# TOWN OF MOUNTAIN VILLAGE REGULAR DESIGN REVIEW BOARD MEETING AGENDA THURSDAY FEBRUARY 6, 2025, 10:00 AM MOUNTAIN VILLAGE TOWN HALL 455 MOUNTAIN VILLAGE BLVD, MOUNTAIN VILLAGE, COLORADO TO BE HELD HYBRID THROUGH ZOOM:

## DESIGN REVIEW BOARD MINUTES TOWN OF MOUNTAIN VILLAGE REGULAR DESIGN REVIEW BOARD MEETING JANUARY 9, 2025, 10:00 AM

# RIDGE LOT 1

Figure 3: Revised Building Height Sections

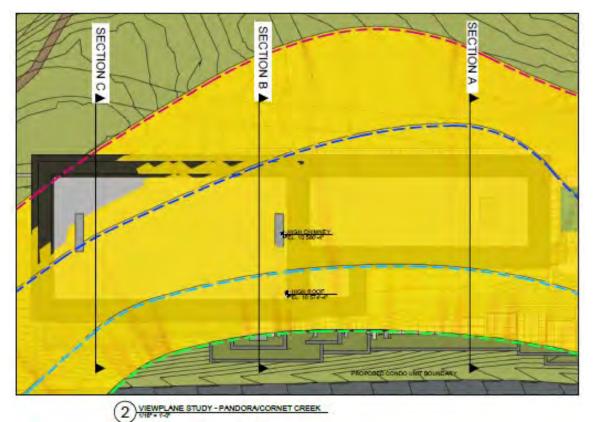
Unfortunately, the Town cannot ascertain whether the View Plane lines provided by the applicant are accurate, which the applicant also confirms in their narrative. The Town's GIS Department has overlaid the building height lines on the aerial survey, which indicates a far different line location on Lot 161A-R2 Unit 1 (please see Figure 5 on the following page). The Town has also created an additional exhibit that shows all lines of the individual view planes in the document referenced in the Stipulated Order (see Attachment D) for the DRB's information. With the applicant's proposal to move the unit line (and the structure) further to the east, it can be assumed that the structure extends far more into the lowest View Plane levels and moving the lot line exacerbates the variance requests. Staff believes that the height variances requested are much larger than those shown in the individual sections in Figures 3 and 4 above.

Figure 12: High Roof Elevation

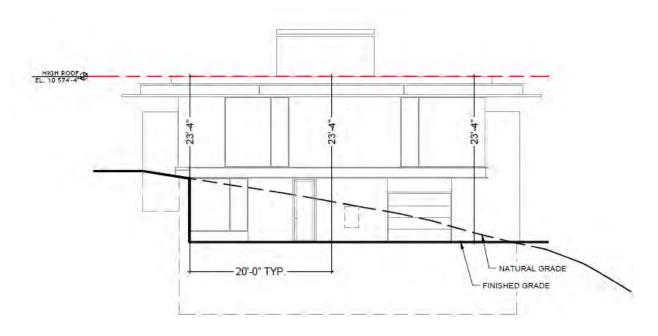
Per Sheet A0.22 of the plan set, the "high roof" for the proposed structure is anticipated to be at a USGS elevation of 10,574'-4", which is 17'-4" over the USGS elevation shown for the View Plane in the View Angle Study (see Figure 12). There are also multiple chimneys that extend above the high roof USGS elevation, with a maximum USGS elevation of 10,580'-4". To staff's knowledge, the Town has not allowed development that has been shown to protrude into the View Plane, as required by the Stipulated Settlement Order.

The Town has approved height variances in this area previously as it relates to the View Plane; however, if approved the Town will require the applicant to indemnify the Town from any claims or damages related to the variance approved. Prior to the issuance of a building permit, the owners shall indemnify, defend, and hold harmless the Town, its members, affiliates, officers, directors, partners, employees, and agents from and against all claims, damages, losses and expenses, including but not limited to reasonable attorney's fees, arising out of the approval of the height variance granted hereunder. Further, should the DRB recommend approval of the height variance, staff would suggest the use of the USGS as the maximum height allowable due to the continued dispute over the applicability of the View Plane. Any recommendation of approval of a height variance shall be conditioned on the use of maximum USGS elevations of 10,574' – 4" for the maximum point of any primary or secondary roof structure and 10,580' – 4" for any chimney structure.

Figure 2. Official View Plane from Plat Book 1 at Page 2601

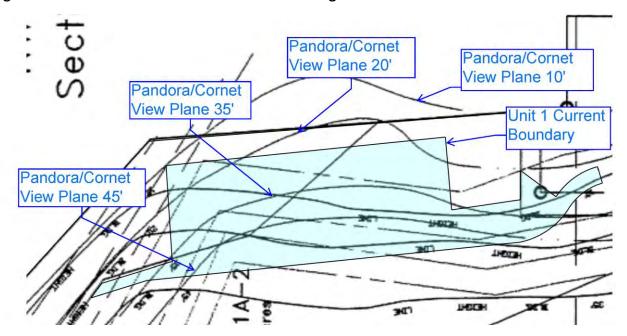
The work session staff memo references the 10′, 20′, 35′ and 45′ heights that were accurately reflected in the work session plan set prepared by Openspace Architecture as shown in Figure 1. Figure 2 shows the View Plane from Plat Book 1 at Page 2601 in comparison.

It is important to note that Openspace Architecture received the View Plane height lines from Steve Morton Architects, which is the architecture and planning firm that created The Ridge Maser Plan ("Master Plan") (Please refer to the Master Plan discussion below). The work session staff memo accepted the View Plane analysis submitted by Openspace Architecture and referenced the View Plan height limits as shown.

Figure 6. Incorrect Application of the View Plane as Jagged Lines and Not a Plane

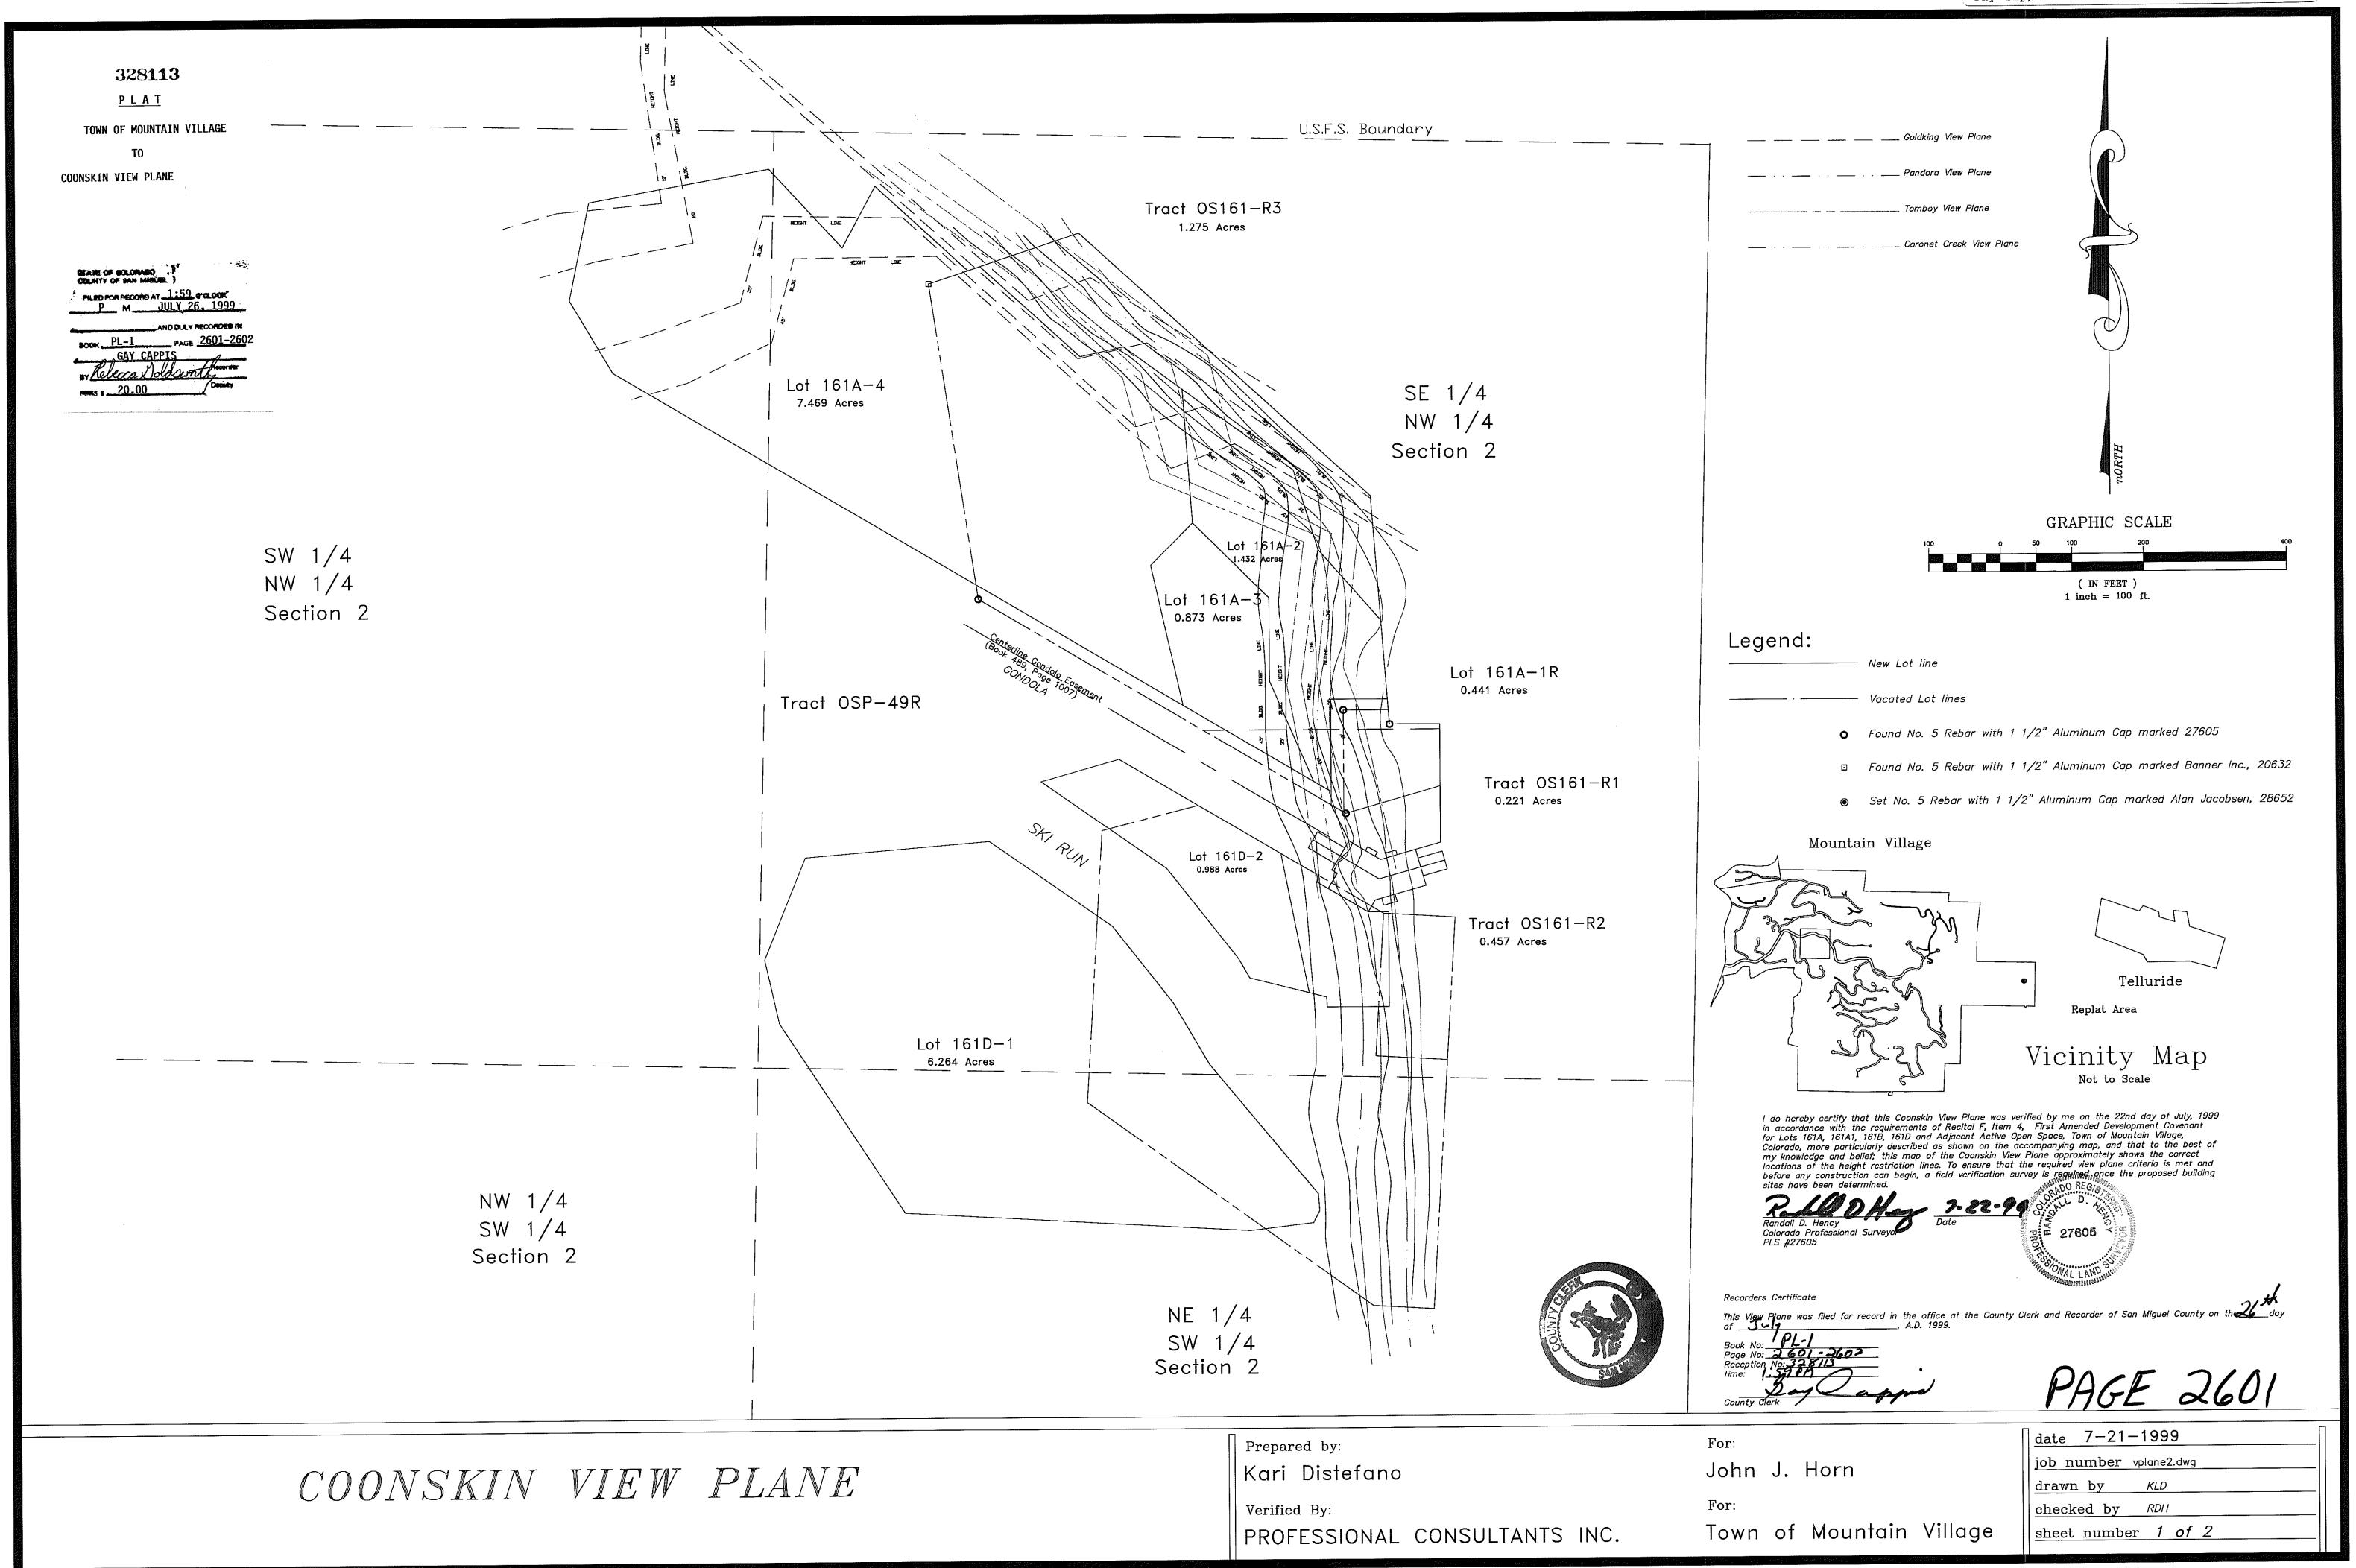
We would also note that the View Plane is correctly shown in Figures 4 and 5 as a plane over the existing topography and not a series of jagged lines that do not reflect the topography or any plane concepts as directed by the Town in the last few years and as shown in Figure 6. The correct application of the View Plane as approved by the Town and DRB in the Master Plan and past development applications at The Ridge shows the View Plane as a plane over existing topography and should be used for the Owner's applications and other future applications at The Ridge.

The Settlement Agreement is clear that the View Plane is recorded in Book 1 and Page 2601. The Town and DRB approval of the Master Plan also set precedence on the correct application of the View Plane consistent with the Settlement Agreement and as a plane over existing topography and not a series of jagged lines as directed by the Community Development Department for the Owner's development applications.

We are requesting that the Community Development Director reconsider decisions made on incorrectly applying the View Plane and how the View Plane is applied as set forth in this letter.
